From: Schiefelbein, Kelvin
Sent: Friday, 22 November 2019 10:31 AM
To: Confidential
Cc: Wynn, Damien; Newton, Bayda; McNally, Tim
Subject: MRE response ISHR inspection
Attachments: 22.11.19 MRE Response - Kelvin Schiefelbein - ISHR Inspection of Single Entry 909 on 1-11-19 - Issued 15-11-19.docx

Stephan Woods,
 Industry Safety and Health Representative
 CFMEU
 PO Box 508,
 Spring Hill, QLD 4004

22 November 2019

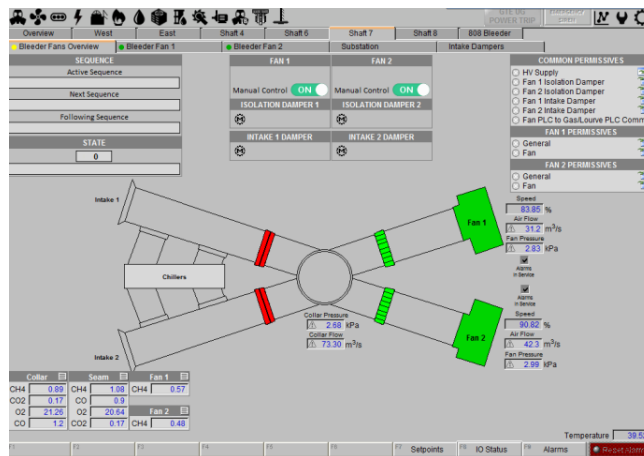
2. The Single Entry MP requires the shaft 7 fans to trip at 2%. Why did they not trip on the 30th if the methane sensor at the base of shaft 7 reached above 2%?

The fans set up on the surface are set up to allow for dilution at the collar of the shaft. This means that air passing through the fan is diluted with surface airflow (approximate dilution is 40%).

Gas sensors on the intake side of the fan are set to trip at 2% in compliance with the management plan and risk assessment covering the operation of this fan. This trigger level was not reached during the restarting of the fans on the 30th/10/2019.

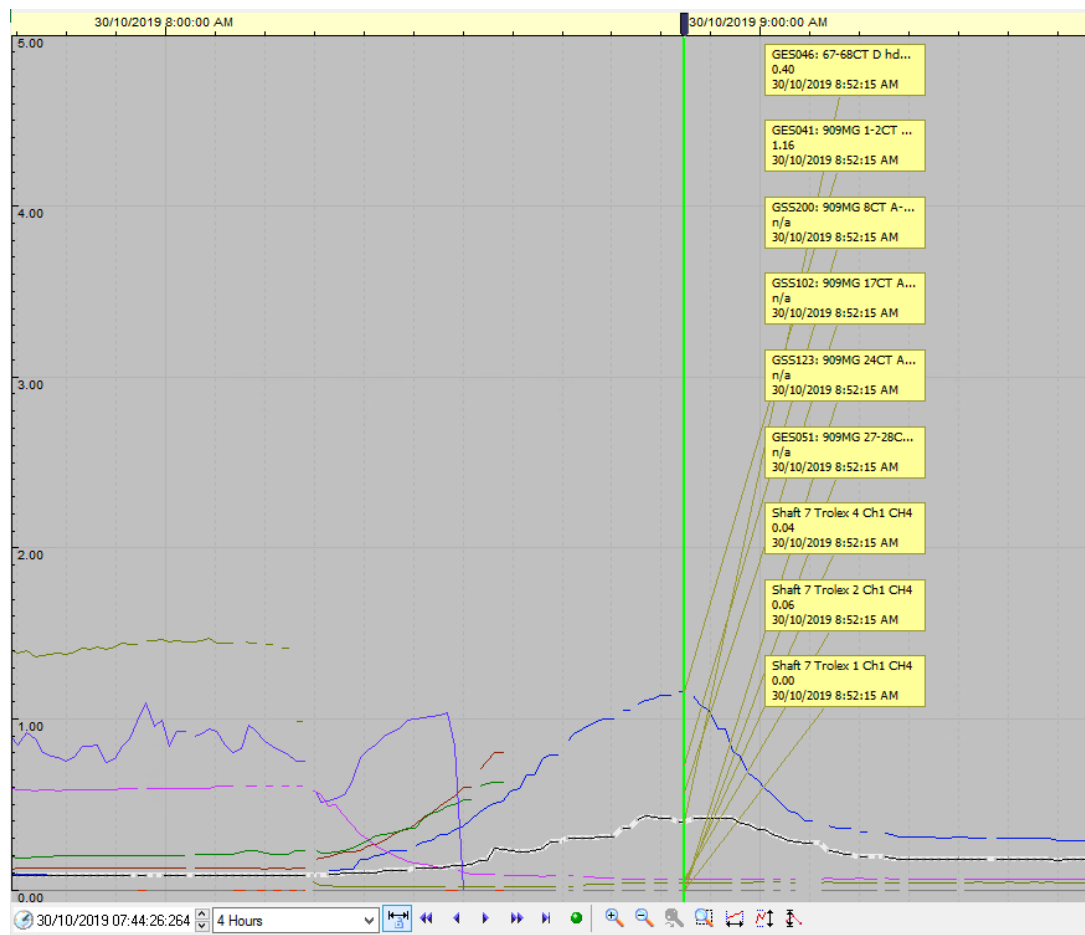
10. During failure of the shaft 7 fan, the air reverses with methane concentrations above 1.25%. This prevents the primary escape way from being trafficable using mechanised equipment. How does this comply with section 298(2) of the CMSHR?

Development work in the panel requires gas levels to be below 1.25% for power to be applied. In this case while development operations are being undertaken roadway would be compliant as a primary egress.

As discussed during your visit the gas concentration recorded during the ventilation reversal was found to be peaked 1.16% and around 0.6% after stabilizing. (eg less than 1.25%)

Also regulation 298 (2) removes the requirement for mechanized travel in workings being driven in either single or two heading developments.

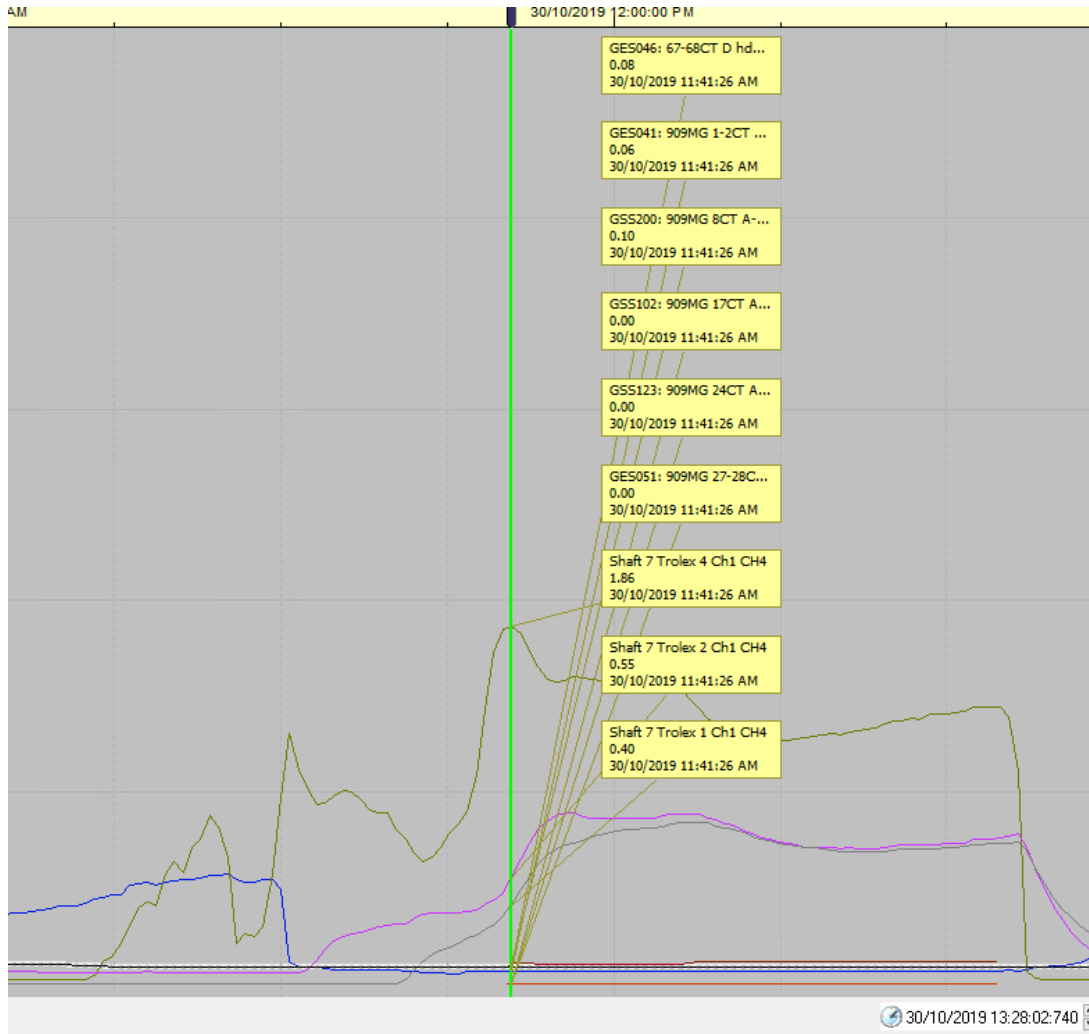
12. Has any modelling been undertaken to determine the length of time it will take with the current emissions with shaft 7 off to reach 2.5% CH₄ described as a dangerous place pursuant to section 366 of the CMSHR 2017.

As per question 11 response.

This is not a likely event with the down-casting arrangement and with the changes in goaf pressure which would occur. The seals would tend to leak inward rather than outward.
